# K Bike Water/Oil Pump Rebuild Using New-Style Seals Update #3

By Nick Stokes

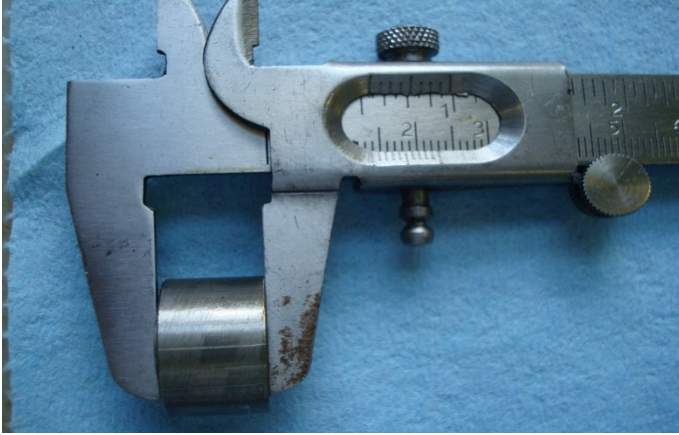
The original seal on my K75S used a spacer bushing 14mm long.

This spacer bushing is too long for use with the new slip-ring seal.

You must have spacer bushing #11511464902 which is 10mm long for use with slip-ring seal #11411741870.
